BEFORE THE FLORIDA PUBLIC SERVICE COMMISSION

In re: Territorial Dispute Between)
Talquin Electric Cooperative, Inc. and)
the City of Quincy)
_____))
DOCKET NO. 20250039-EU

**CITY OF QUINCY'S RESPONSES TO THE PSC's
THIRD DATA REQUEST**

EXHIBIT A

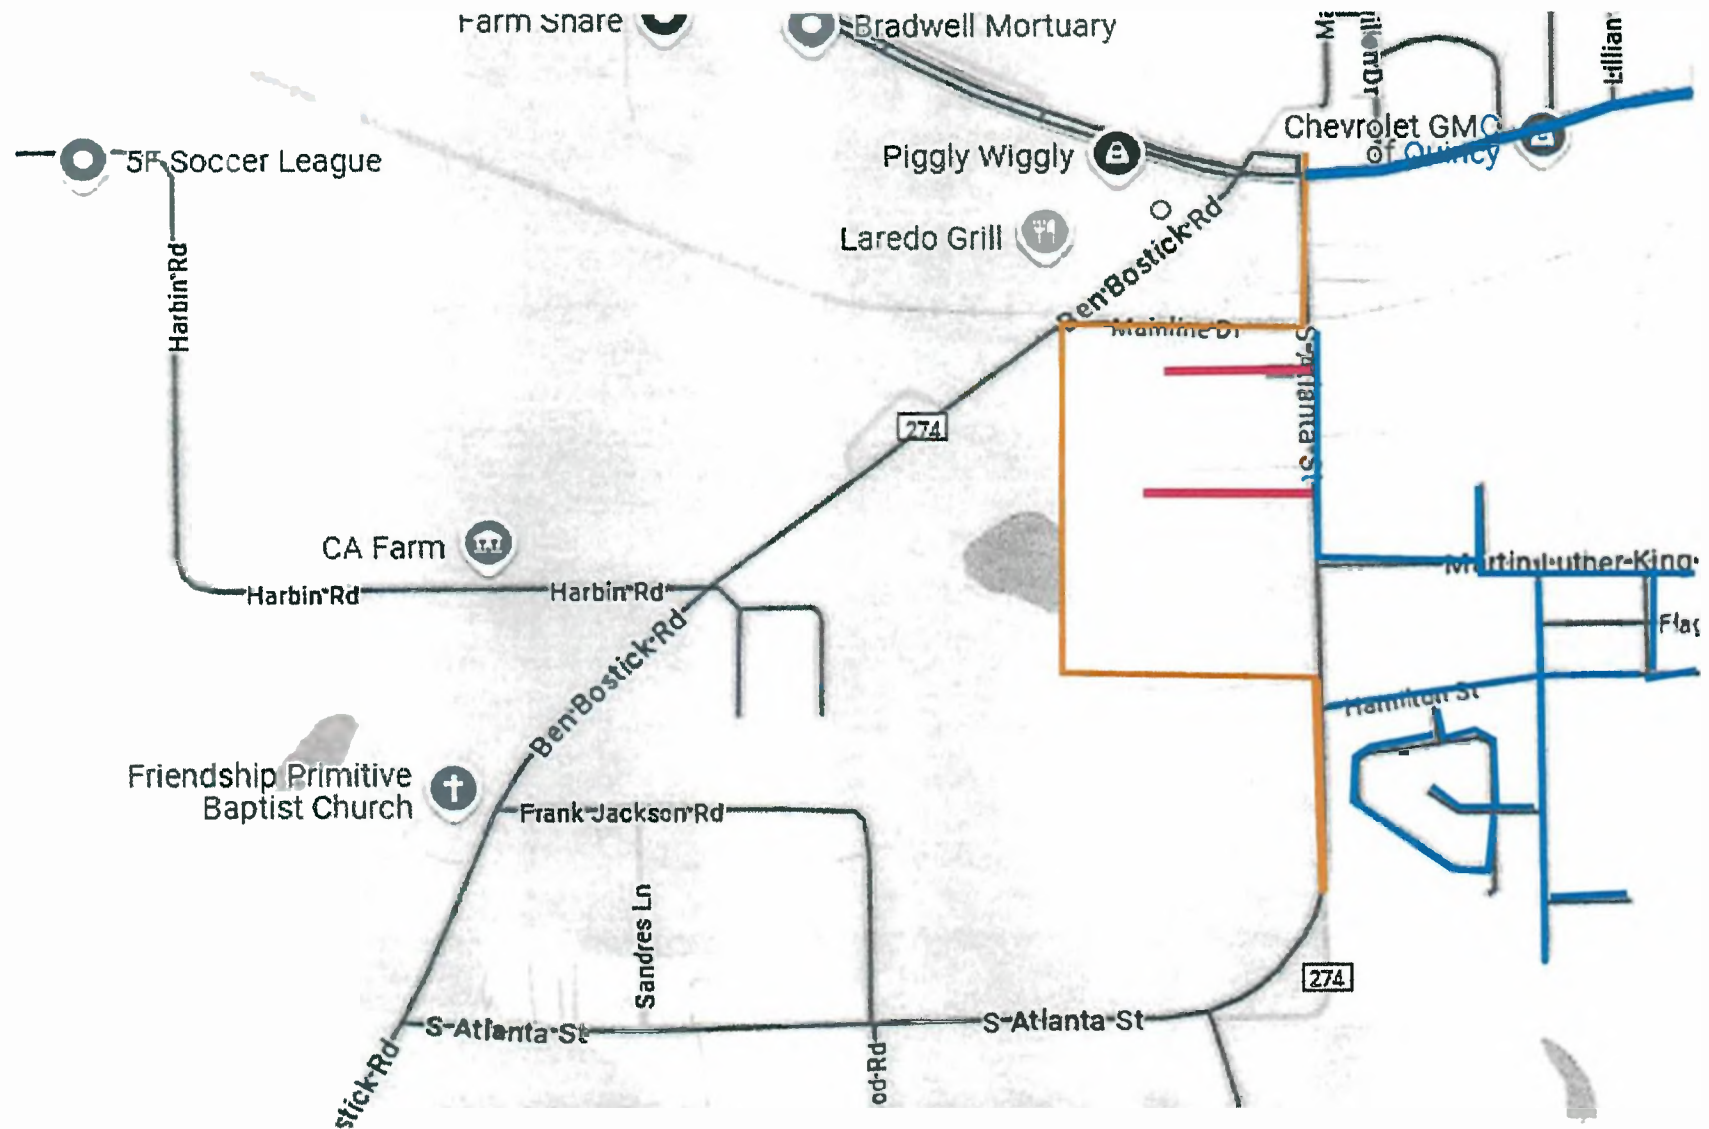
PSC TDR 1. "Overlaid on the map provided, please provide clearly defined designations (with a key) of the 1995 territorial boundaries. If necessary, the provided map can be expanded or cropped to allow sufficient space for the requested detail."

PSC TDR 3. “Overlaid on the map provided, please provide clearly defined designations (with a key) of Quincy’s existing service facilities. If necessary, the provided map can be expanded or cropped to allow sufficient space for the requested detail.”

See page 1 of Exhibit A to this Response. The 1995 Territorial Boundary is marked in rust/orange. Page 2 of Exhibit A locates the area depicted on the 1995 Territorial Map.

See Exhibits A and B to this Response. QE’s primary distribution lines are in blue, and existing residential lines are in magenta. The existing residential lines depicted serve the Parkview Garden and Parkview Manor apartments. The Parkview apartments are multi-family residential developments that have been served by Quincy Electric since construction, circa 1979

EXHIBIT B

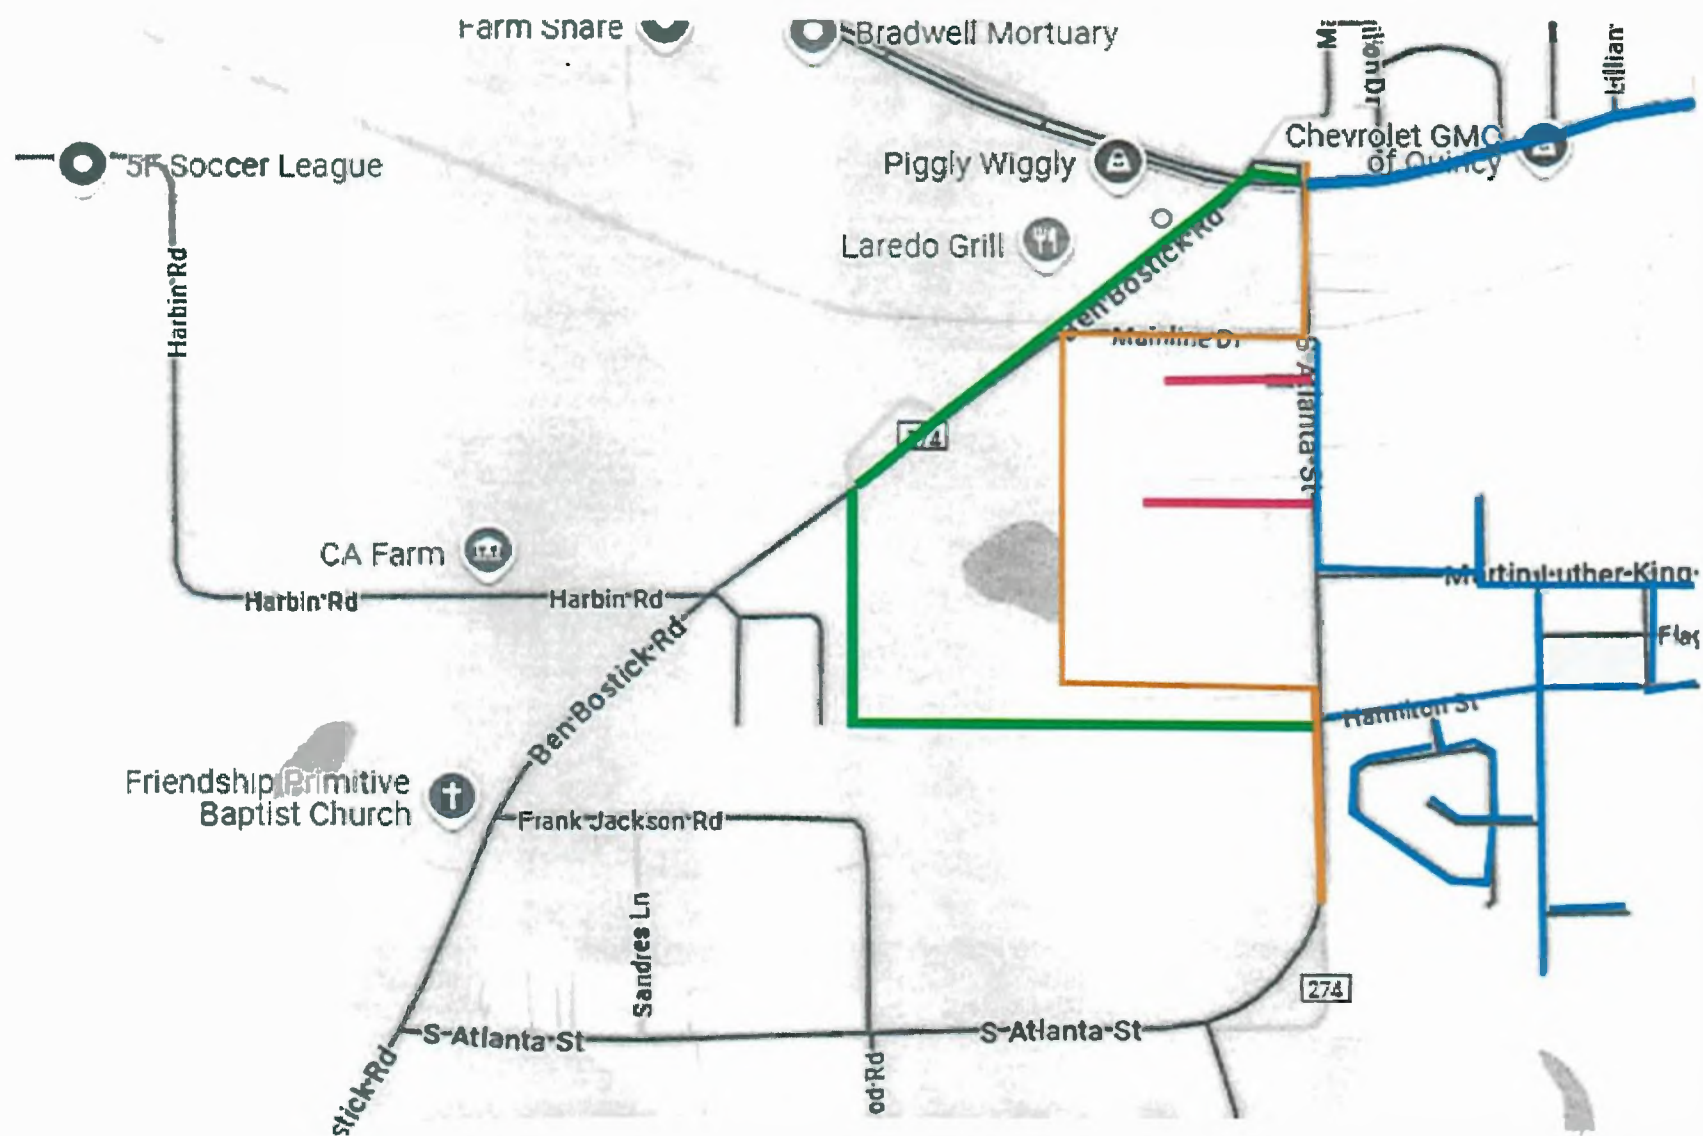
PSC TDR 2. "Overlaid on the map provided, please provide clearly defined designations (with a key) of the existing territorial boundaries. If necessary, the provided map can be expanded or cropped to allow sufficient space for the requested detail."

See Exhibit B to this Response. Territory annexed by the City in February 2025 is indicated in green.

EXHIBIT C

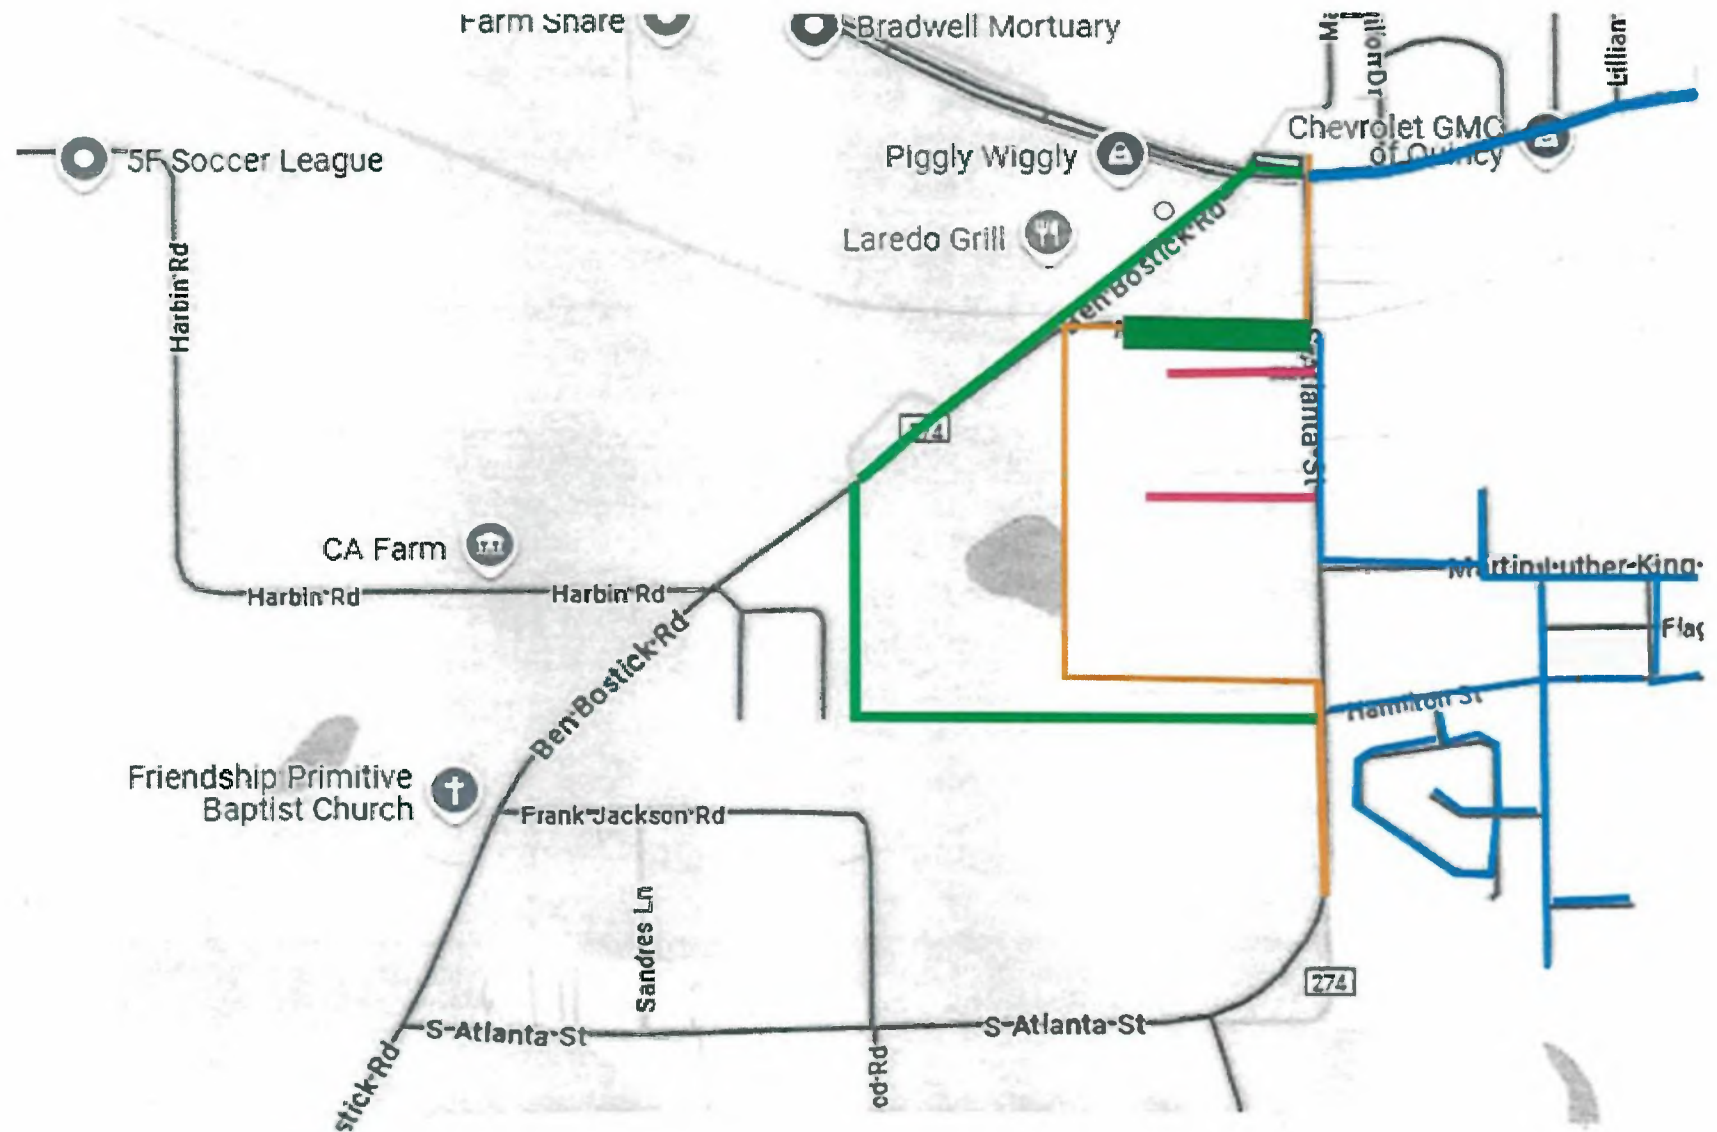
PSC TDR 4. “Overlaid on the map provided, please provide clearly defined designations (with a key) of Quincy’s proposed serving facilities. If necessary, the provided map can be expanded or cropped to allow sufficient space for the requested detail.”

See Exhibit C to this Response. The proposed extension to QE’s primary distributions lines is depicted in forest green. Note that QE has modified its current plan to electrify the proposed new developments since filing of its responses to the FDR and TDR. We no longer plan to cross Bostick Road.

This change in plan reflects and was driven by Gen Land’s finalization of the Phase 1 platting. Further explanation will be provided in a forthcoming supplement to Quincy’s Opposition to the Talquin Petition, planned for filing early in the week of May 19, 2025.

EXHIBIT D

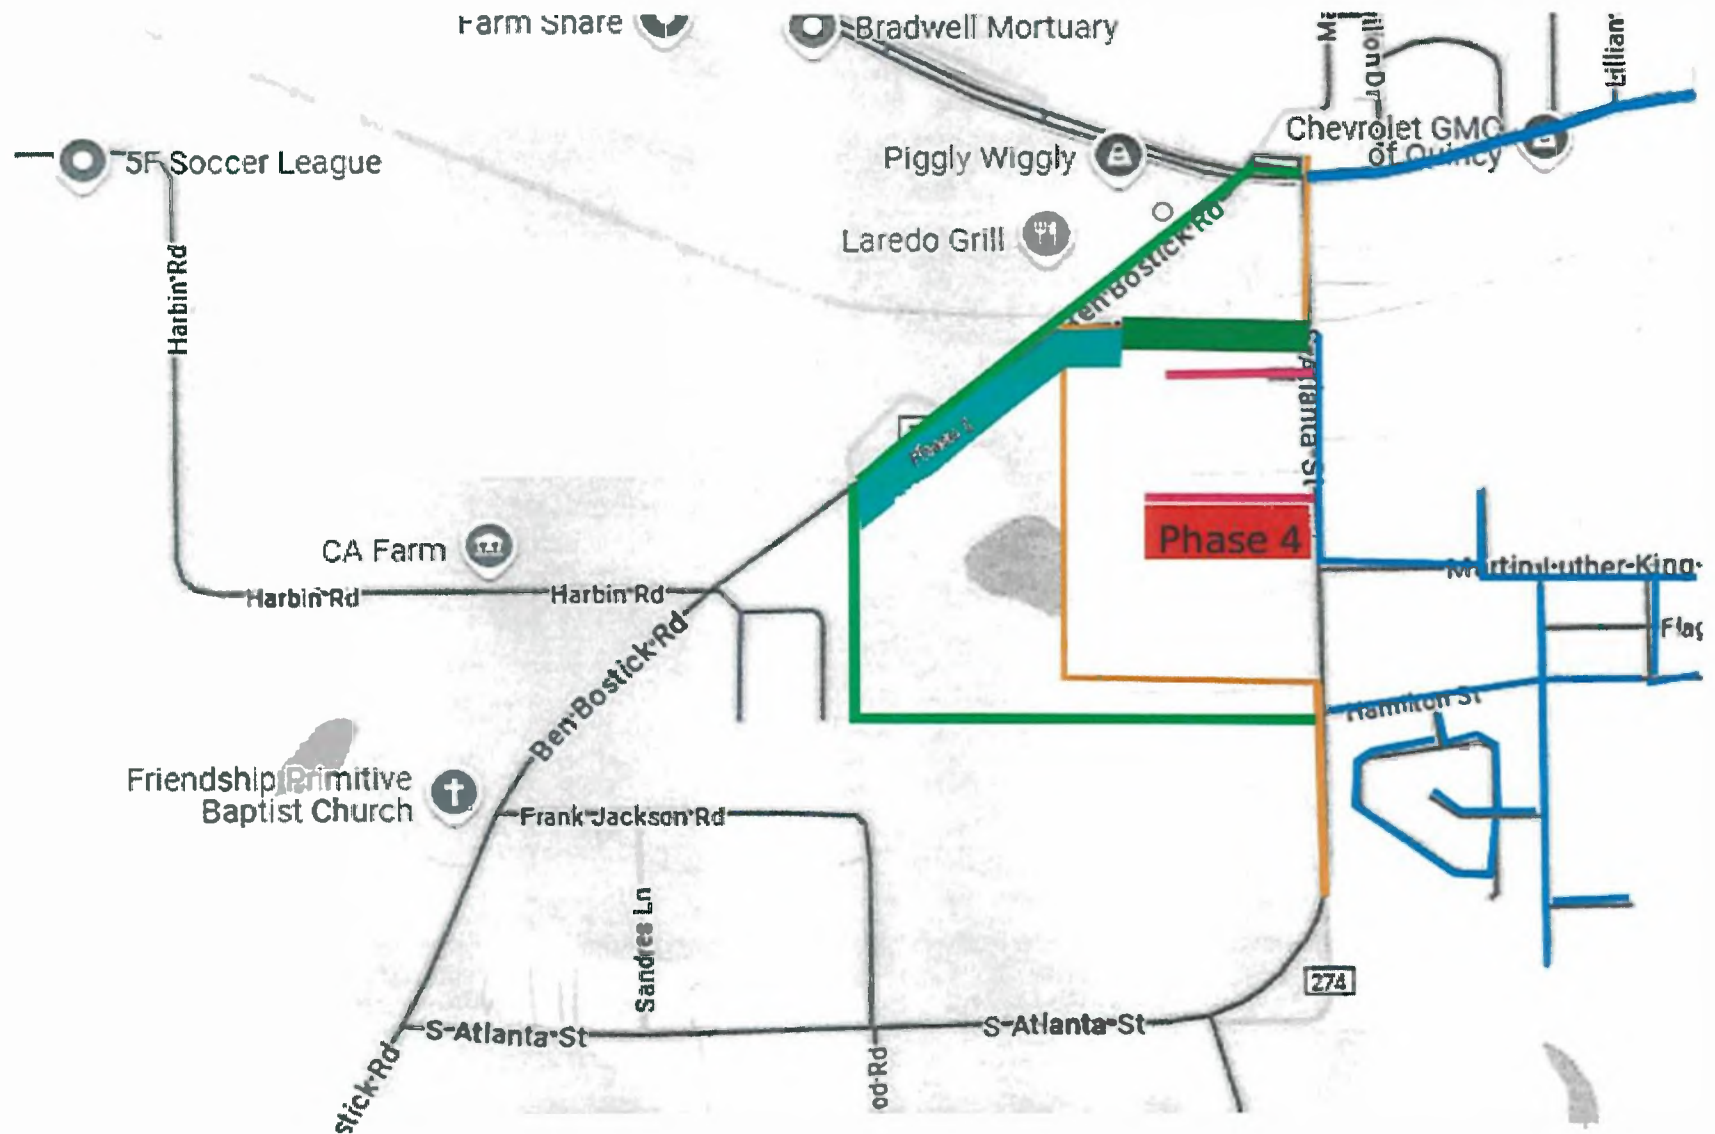
PSC TDR 5. “Overlaid on the map provided, please provide clearly defined designations (with a key) of Phase 1 through Phase 4 of the proposed development areas. If necessary, the provided map can be expanded or cropped to allow sufficient space for the requested detail.”

See Exhibit D. Page 1 depicts Phase 1 in teal and Phase 4 in bright red. Page 2 includes the area of Phases 2 and 3 in yellow. Page 3 is the Gen Land plat map, previously exhibited by Quincy’s Response to the SDR.

- 1995 Territorial Agreement Boundary
- Territory Annexed by Quincy February 2025
- Phase 1
- Phase 4

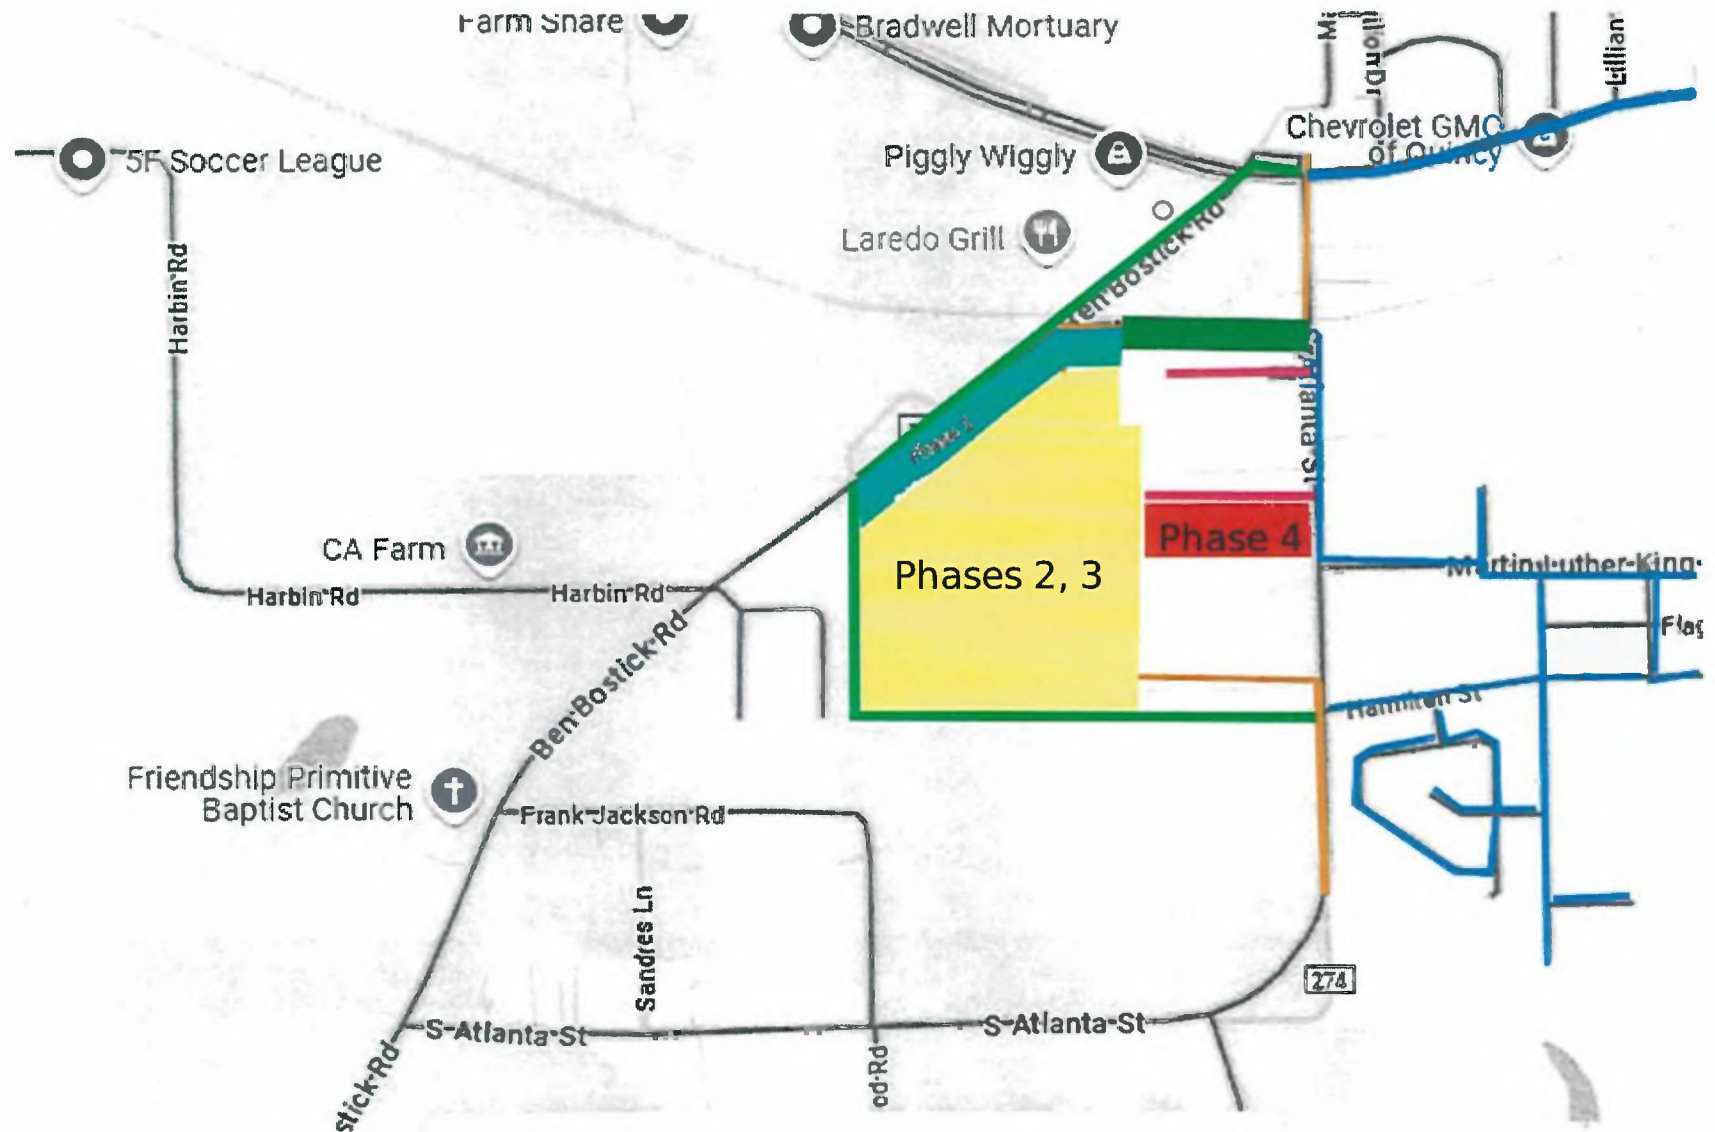
PSC TDR 6. “In response to Staff’s First Data Request No. 5.b., Quincy stated, ‘As detailed in Quincy’s Opposition, granting Talquin’s Petition would bring the distribution equipment, lines and transformers on the two utilities into dangerous and unnecessary physical proximity.’

Please indicate on the maps provided the area(s) where Quincy believes the electric facilities will be in dangerous and unnecessary physical proximity if Talquin provides electric service to:

- Bostick property, exclusive of Phase 4 of the development project. (Map 1)
- Bostick property and Phase 4 of the development project. (Map 2)”

As depicted in Exhibit D, page 2, Phase 4 is adjacent to both existing residential connections and QE’s primary distribution line from the South substation. There also is currently no public right of way for Phases 2 and 3, and any potential access will directly border the residential areas directly east of the development. This includes proximity of Phase 1 to the Parkview Garden apartments.
